Base WD: 203B0000

Circuit Diagram Number 203B0000 of 2

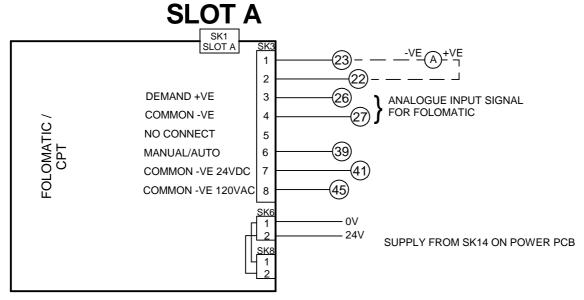
400v added to type 1

sheet 2 note 1.

tapping Y. Note added to

Updated notes on page 2
